# Access Compliance Report

## Public Rights-of-Way

Intersection ID: 29245	Main Street: CAYMUS_DR	Cross Street: MALLARD_FOREST_DR	Location: SW
ADA ID: FAD72BFFA193	Ramp Type: BlendTrans1	Initial Pass/Fail: Fail	Overall Compliance: No
		Severity Score: 8.75

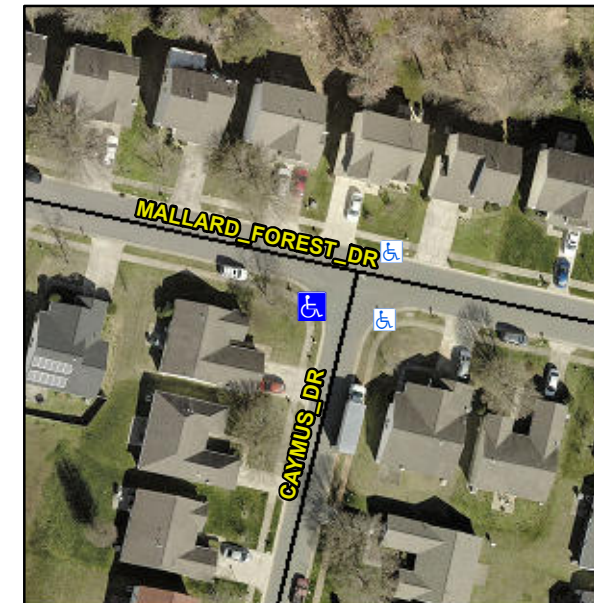
**Not Found, R304.5.1**

Compliance	Description	Data	Compliance	Description	Data
N/A	Ramp Length (in)	48.0	Yes	BlendTrans Slope (%)	3.1
No	Ramp Width (in)	47.0	Yes	BlendTrans XSlope (%)	1.9
N/A	Flare Type LT	N/A	N/A	Flare Type RT	N/A
N/A	Flare Slope LT (%)	N/A	N/A	Flare Slope RT (%)	N/A
N/A	Flare Traversable LT?	N/A	N/A	Flare Traversable RT?	N/A
N/A	Landing Length (in)	N/A	N/A	DWS Provided?	N/A
N/A	Landing Width (in)	N/A	N/A	DWS Contrast?	N/A
N/A	Landing Slope (%)	N/A	N/A	DWS Length (in)	N/A
N/A	Landing X Slope (%)	N/A	N/A	DWS Full Width?	N/A
N/A	Landing Curb? (Y/N)	N/A	N/A	DWS Offset (in)	N/A
N/A	Shared Landing?	N/A			
N/A	Gutter Ponding?	N/A	N/A	Gutter Slope (%)	N/A
N/A	Gutter Lip Ht (in)	0.5	N/A	Gutter X Slope (%)	N/A
N/A	Painted X Walk1?	No	N/A	Painted X Walk2?	No
	X Walk 1 Direction	To E		X Walk 2 Direction	To N
	X Walk 1 Width (in)	N/A		X Walk 2 Width (in)	N/A
	X Walk 1 Slope (%)	3.8		X Walk 2 Slope (%)	4.2
	X Walk 1 X Slope (%)	2.0		X Walk 2 X Slope (%)	0.3

N/A	Ramp inside XWalk1?	N/A	N/A	Ramp inside XWalk2?	N/A
	Road Slope (%)	1.0		Clear Space?	N/A
	Road X Slope (%)	1.3	N/A	Clear Space to XWalk (in)	N/A
N/A	Any Obstructions?	N/A	N/A	Storm Grate/Utility Hazard?	N/A
	Obstruction Type			Storm Grate/Utility Type	
		N/A			N/A
			Yes	Surface Condition? (G/P)	Good
			No	Curb Slope (%)	11.7

**Remove & Replace Curb Ramp With Two New Directional Ramps or Equivalent.**
